Committee of the Whole Report

Subject: Development Permit with Variance Application No. 00129 for 1035 Joan Crescent

The purpose of this report is to present Council with information, analysis and recommendations for a Development Permit with Variance Application for the property located at 1035 Joan Crescent. The proposal is to construct a semi-attached dwelling. The variance is related to

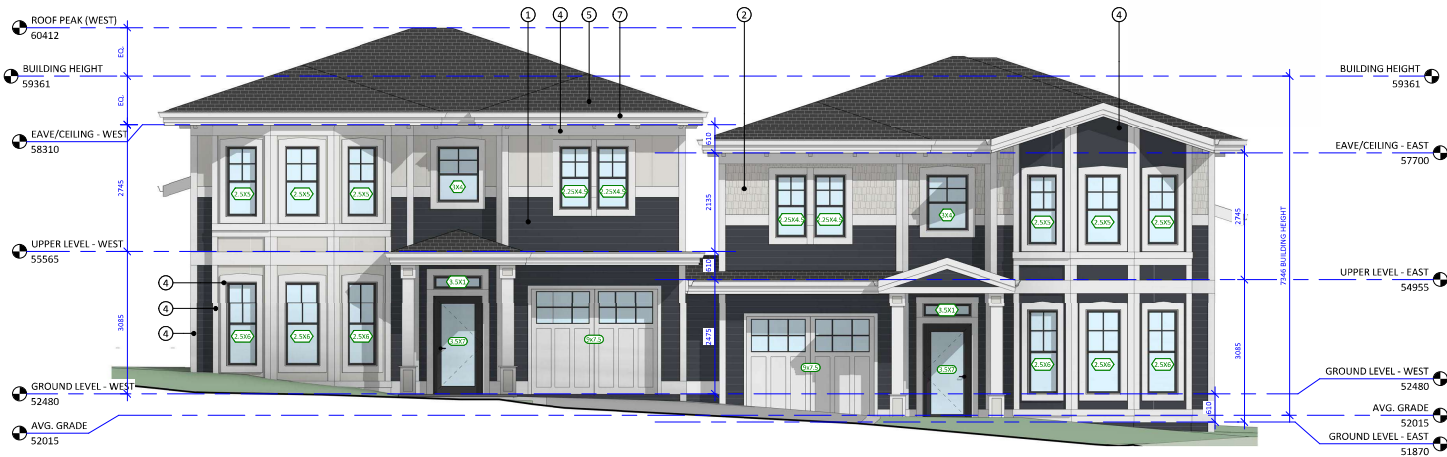
The Governance and Priorities Committee Report of November 23, 2010 refers to; Para. 1 “Attached and semi attached being attached thru a common-roof structure. This would help ensure there is a structural connection between dwellings.” In the plans presented structural connection appears to be minimized.

Further, while the Roof Plan, Page 8, 1-A3.01 appears to show a co-joined roof line the architects drawing of Page 1 clearly shows the main roof line is not joined.

The RNA LUC requests that Planning and Land Use Committee clarify the issue of the common- roof structure.
